PARK CITY MUNICIPAL CORPORATION PLANNING COMMISSION CITY COUNCIL CHAMBERS November 8, 2017

Treasure Hill Conditional Use Permit, Creole Gulch and Town Lift Mid-station Sites –
Sweeney PropertiesPL-08-0037072Sweeney PropertiesPlannerMaster Plan – PL-08-00370AstorgaPublic hearing and consideration of motion to continue public hearing to November

PARK CITY MUNICIPAL CORPORATION PLANNING COMMISSION MEETING MINUTES COUNCIL CHAMBERS MARSAC MUNICIPAL BUILDING OCTOBER 25, 2017

4. <u>Treasure Hill Conditional Use Permit, Creole Gulch and Town Lift Mid-station</u> <u>Sites – Sweeney Properties Master Plan</u> (Application PL-08-00370)

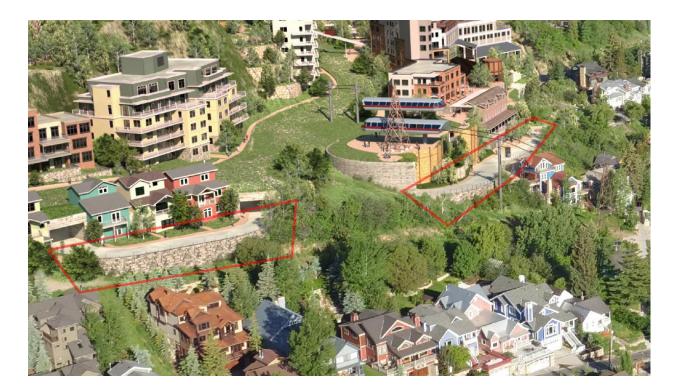
Staff is specifically concerned with the first listed setback exception as it restricts (retaining) walls to no more than four feet (4') in height (measured from final grade). Supplemental Regulations (LMC 50th Edition) Chapter 4 § 15-4-2(A) reiterates the same regulation listed under the exception as it also clarifies that through an administrative CUP approval (reviewed by the Planning Commission) a retaining wall may exceed six feet (6').

Refinement 17.2 contains a driveway accessing the site from the Lowell-Empire switchback parallel to Building 2 extending below the ski lift which enters into an underground passage towards an en exposed driveway parallel to Building 1A before returning again to another tunnel towards the underground parking structure underneath Building 1A, 1B, and 1C. This entire driveway from Creole-Gulch site extending towards Mid-Station site is supported by a retaining wall on its east side which exceeds the maximum retaining wall exception of four feet (4'). In conjunction with this CUP the Planning Commission can further approve the maximum height (measured from final grade) of this proposed retaining walls, additionally the Applicant has not request an exception. Staff is unable to verify the exact height of this wall based on the submitted plans of Refinement 17.2; however, it can easily be determined that this proposed retaining wall will be over four feet (4') from final grade. See rendering below with the identified retaining walls areas over four feet (4'):

Does the Planning Commission agree with staff analysis which designates the front setback area the same as the delineated 0'-0" maximum building height area? Does the Planning Commission agree with staff that the same front yard exception outlined in the Estate District would apply to the Creole-Gulch and Mid-Station sites?
